San Diego Regional Water Quality Control Board

Subject: August 11, 2015 San Diego Water Board Inspection Report

**MUNICIPAL SEPARATE STORM SEWER SYSTEM (MS4)
AUDIT INSPECTION REPORT**

FACILITY: City of Escondido MS4

Photo 1(a): Google earth aerial view of Ryan Park parking lot, and location of bioswale BMP.

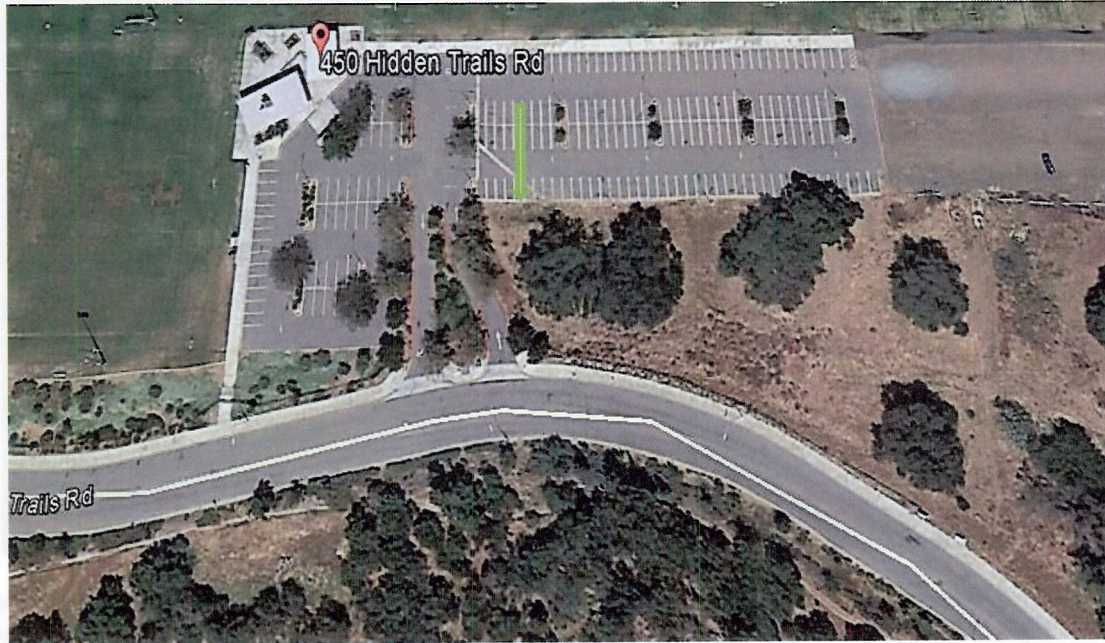
- a) According to City's design plans, Ryan Park is intended to have 1 bioswale to address runoff from the parking lot (see photo 1(a)).
- b) City inspections of the site indicate "BMP Operational, in compliance" from 2009-2014. Notes from City's 2015 inspection indicate issues with sediment buildup and grade problems.
- c) Site observations were as follows:
 - The bioswale was in designed location and vegetated.
 - Sediment buildup was evident in the parking lot and inlet appears to be constructed higher than bioswale.
 - Trash was noted in the bioswale.
- d) The City reported that, based on the City's inspection findings, they intend to do street sweeping and regrade the bioswale.

Conclusion: City findings in Attachment 2 are comparable with San Diego Water Board staff findings. The bioswale needs maintenance and re-contouring of the bioswale flow path to avoid flow backing up and sediment deposition in the parking lot. However, the likelihood of pollutants leaving the site and entering the MS4 is minimal. The City should provide documentation of any maintenance activities performed on swale to add functionality to the BMP.

Photo 1(b): Inlet to bioswale from parking lot, ground higher than inlet preventing flow to enter swale, trash present, needs maintenance and contouring to allow flow to enter swale. Evidence of sediment buildup at inlet. Parking lot could use a sweeping.

Photo 2(e): Inspectors removed manhole and observed water having discharged through hi-flow bypass directly into Escondido Creek. Unable to determine if low-flow bypass to bioswale is present or functional.

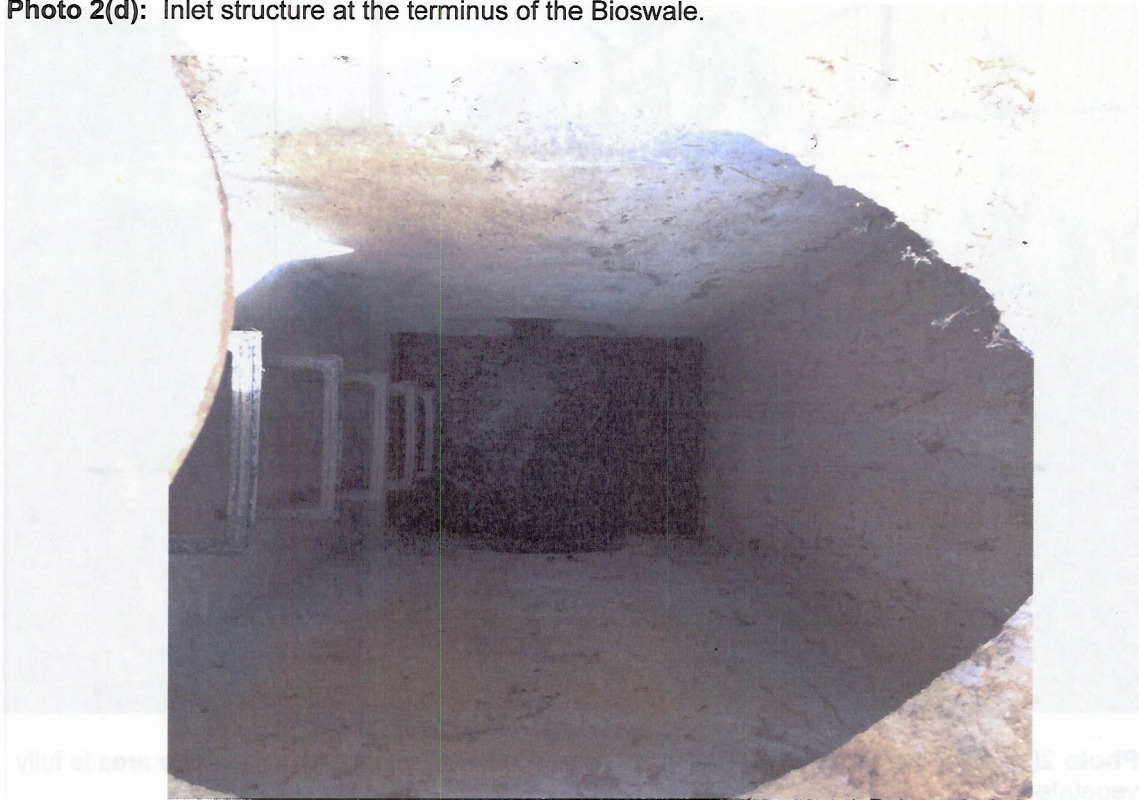
Conclusion: Despite a thorough search by inspectors, the low-flow outlet to the bioswale was never located. It is unclear whether the low flow bypass is working or was ever constructed as per plan. Moreover, there should not have been any flow in the high-flow bypass if the BMP were constructed as designed. If the City is not able to document that the low flow outlet is present and the BMP was constructed as designed, the San Diego Water Board staff conclude that this is a poorly designed and ineffective BMP. Without the low flow bypass stormwater would be discharged directly into

Based on the City's prior inspection findings, the first three years inspectors were unable to locate the BMP, and it is unclear if an adequate inspection has ever been conducted by City personnel to determine if the BMP was functioning as designed. The City's self-certification program should require PDPs to provide photo documentation of BMPs, to better enable the City to determine, and document the effectiveness of BMPs. The City must provide documentation to show this BMP was built and functions per the plans.

Photo 3(c): A majority of the inlet pipes' outer flanges extending into the gutter were broken off (likely from cars parking along the street). This reduces the ability of the inlet pipes to collect stormwater flow and passes it down the street.

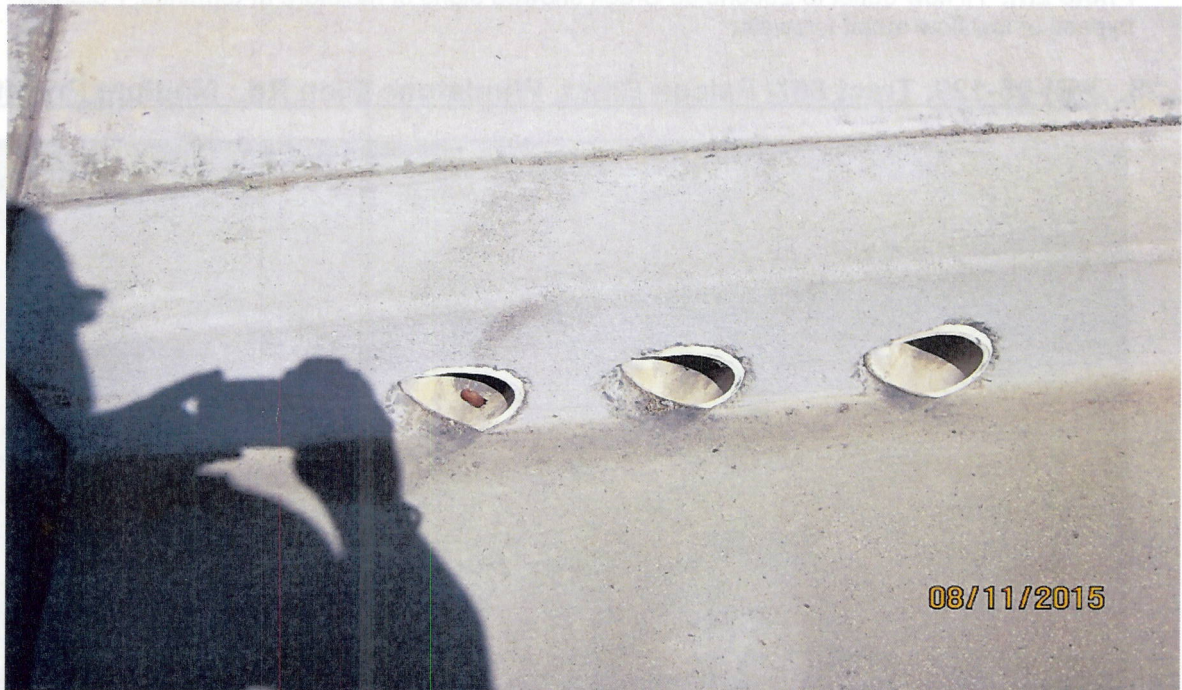
- A majority of the curb inlet pipes' outer flanges were broken off from where they extended into the gutter, leaving them flush with the curb (see photo 3(c)). This reduces the ability of the inlet pipes to convey stormwater to the bioswales. This is a poor design for the inlets and could be improved upon.
- A majority of the inlet pipes were obstructed with sediment and debris (see photos 3(d) and 3(e)). This further reduces the ability of stormwater to enter the bioswale and receive treatment. This observation is consistent with previous City inspection findings in 2011 and 2012.

Based on this inspection San Diego Water Board staff conclude that without major improvements to the inlet structures of these bioswales, stormwater runoff generated on this site receives little or no treatment, and discharges to the MS4 in violation of Order R9-2007-0001 discharge prohibitions and SUSMP requirements. The City should take a close look at the design and functionality of the bioswales and work with the HOA to find a solution to the obvious deficiencies.

Photo 4(a): Google earth aerial view of 613 E. Lincoln commercial day care center.

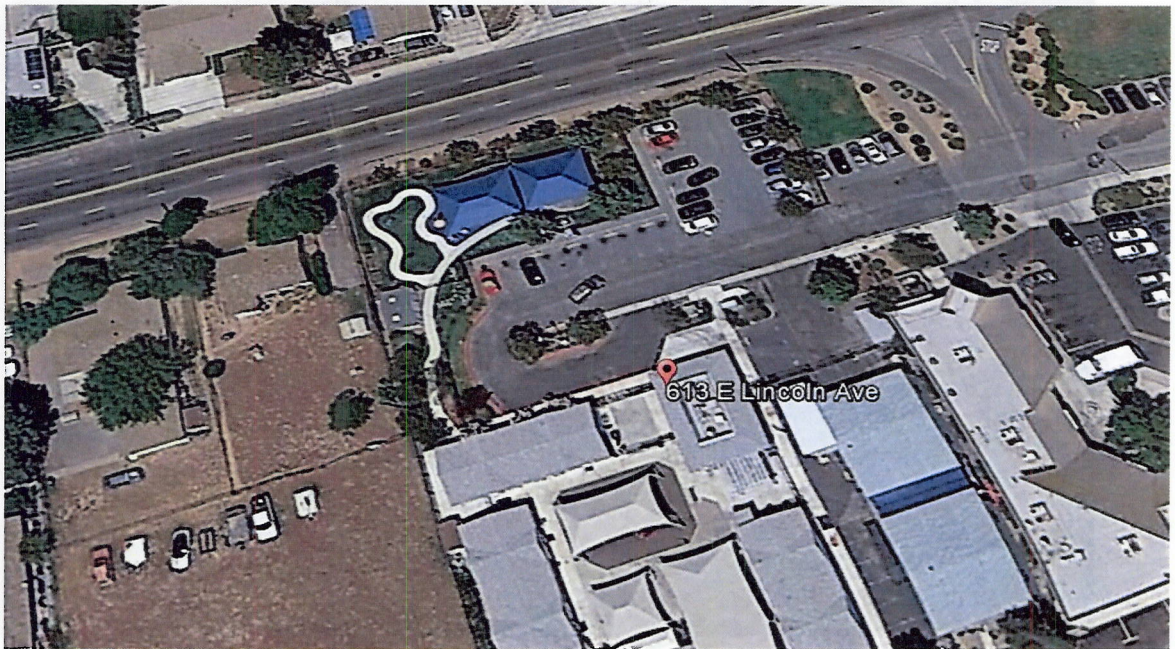
- a) Although this site is a commercial day care facility, the City of Escondido is listed as the responsible party because they own the property and leases it to the day care (see Photo 4(a)). According to City design plans the structural post-construction treatment control BMPs for this site include two inlet filters and two bioswales.
- b) City's inspection findings for the site are as follows:

Conclusion: 3 out of 4 BMPs, were in place. One bioswale was missing. Past inspection results (2009-2012) indicated that vegetation was insufficient in bioswale, but failed to recognize that one of the bioswales not implemented per plans. Consistent with City inspection findings at other sites, when problems are noted for multiple years, it appears that the City has failed to ensure that these deficiencies are remedied. As land owner of the property the City should go back in and ensure that bioswales are implemented per plan, and should perform maintenance on both inlet filters. Until improvements and maintenance are conducted the site is violation of SUSMP requirements due to lack of treatment for a portion of the parking area.

Photo 5(a): Google aerial view of 426 Date Street. Red arrow indicates where BMP should be located.

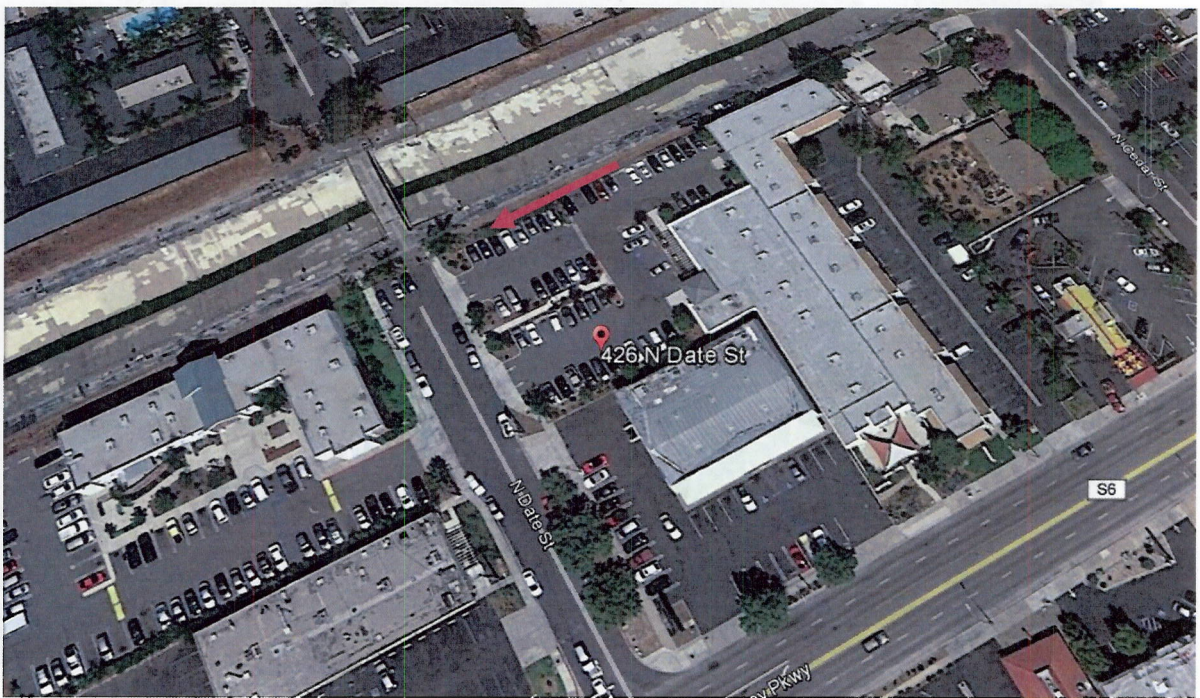
- Bioswale appears to have been constructed in wrong location; i.e. offsite and in City right-of-way. The flow of stormwater from a single curb cut at the low point of the parking lot bypasses sparse vegetation in the City right of way and travels across dirt to a storm drain inlet which is surrounded by gravel and straw wattles (see photo 5(b)).
- The vegetated strip within the project boundary, below the parking lot, seems to be the original intended location of the treatment BMP, but is sloped away from parking lot towards the City's right of way beyond the fence (see photo 5(c)).
- The existing condition of the property does not allow stormwater to undergo any treatment prior to discharge to the MS4.

Conclusion: The City's past inspections (2009-2012) noted a lack of vegetation in the bioswale for years, but offers no indication that the property owners were informed of the fact or required to improve the BMP. The project was noted to be in compliance in 2014, but based on San Diego Water Board observations it does not seem possible that this project has ever been in compliance.

The City should contact the property owners and request that the vegetated area within the project boundaries be regraded and revegetated to become a functioning bioswale. Until such a time as these improvements are made the BMP should be considered missing and in violation of Order R9-2007-0001.

Photo 6(a): Google aerial view of Audi dealership, 1556 Auto Parkway. Arrows indicate location of bioswales.

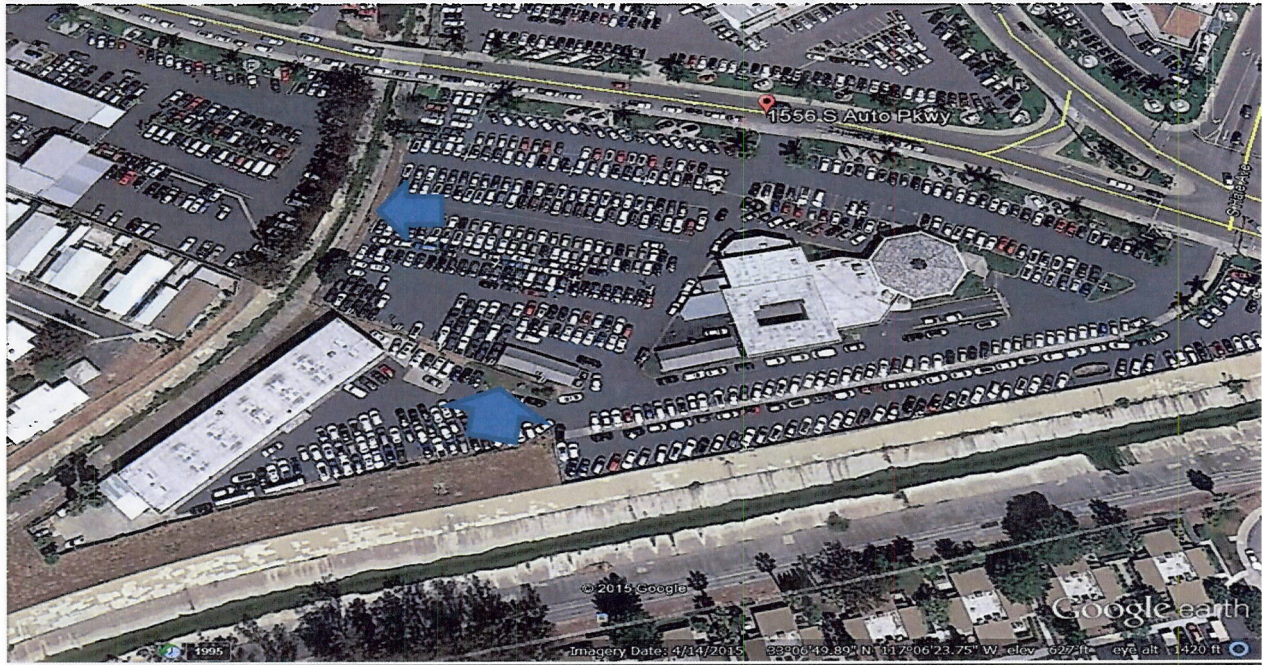
a) This site is a commercial Audi dealership. According to City design plans the structural post-construction treatment control BMPs for this site include 2 bioswales (see photo 6(a)).

Conclusion: Past City inspections for this high priority PDP (2009-2014) have consistently found this PDP to be in compliance with Order R9-2007-0001. San Diego Water Board inspection findings are in direct contradiction with the City's findings. The design of the smaller bioswale is such that, even if it was vegetated along the flow path, the steepness of the slope would preclude pollutants from receiving the necessary retention time to receive treatment. It is a poorly

Photo 6(h): Drain inlet to MS4 from larger swale contained organic debris and should be maintained prior to rainy season.

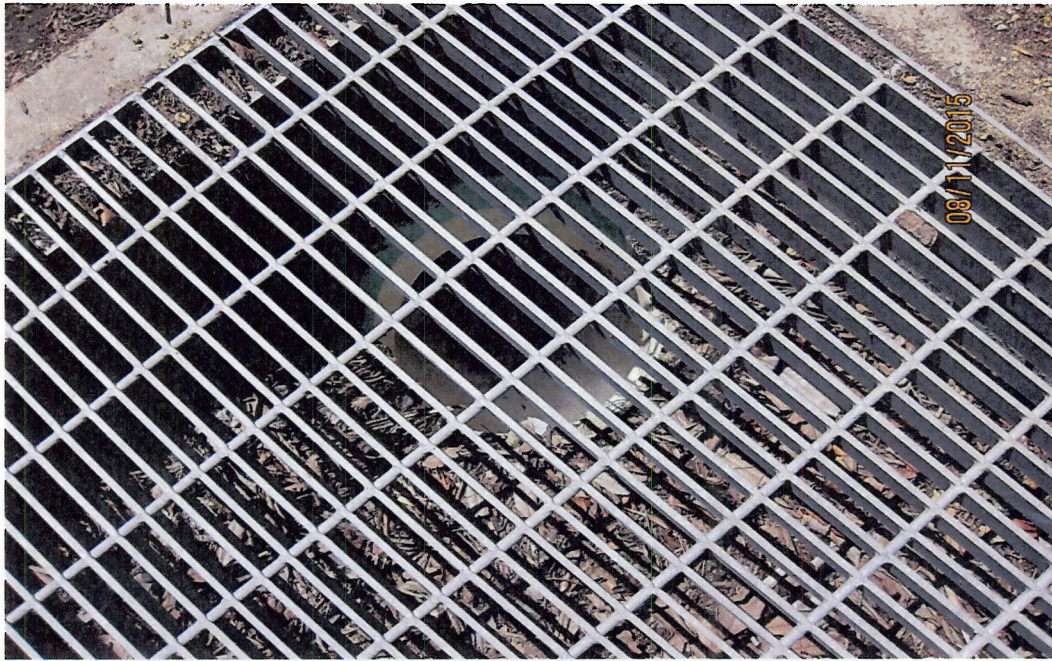
- City staff is working with Audi representative to vegetate swale bed before October 1, 2015.
- Drain outlet from swale had a significant amount of organic debris inside, and is in need of maintenance prior to rainy season (see photo 6(h)).

Photo 7(a): Google aerial view of 125-133 Pennsylvania Ave. Blue arrow denotes approximate location of bioswale.

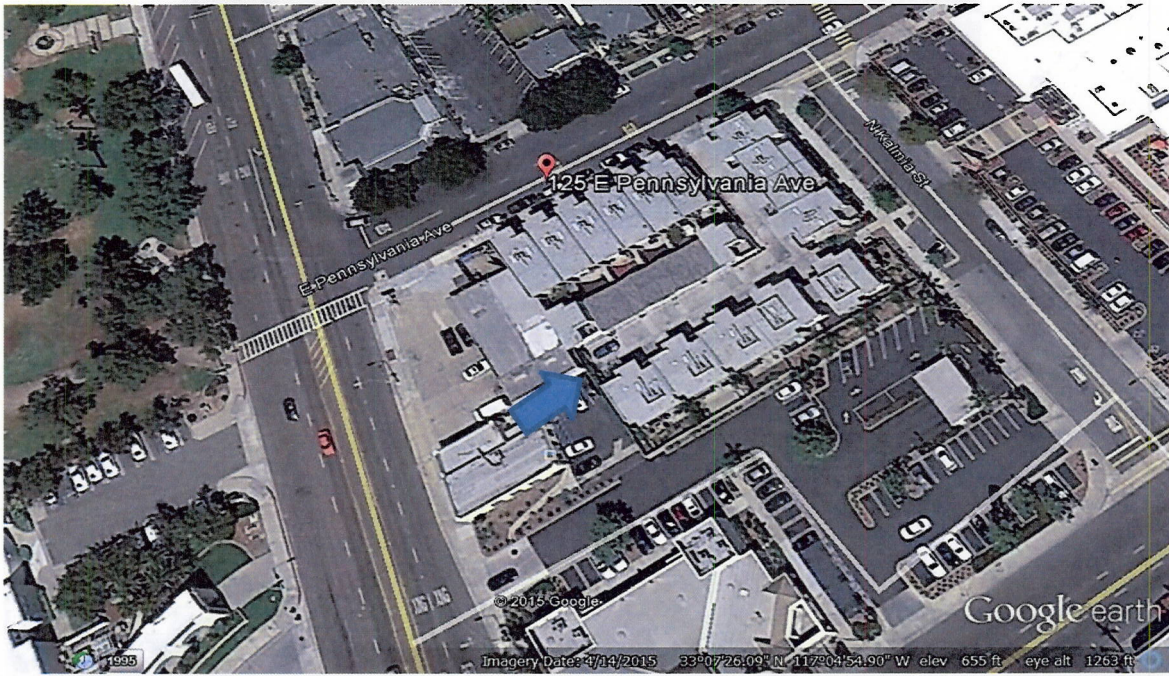
a) This site consists of residential apartment housing. According to City design plans the structural post-construction treatment control BMP for this site includes 1 bioswale. The bioswale drains the interior pavement of the complex, passes under a residential fence (see photo 7(b)), through the side yard, and into the City MS4 (see photo 7(c)).

Conclusion: Bioswale exists as per plans, is vegetated, and is compliant.
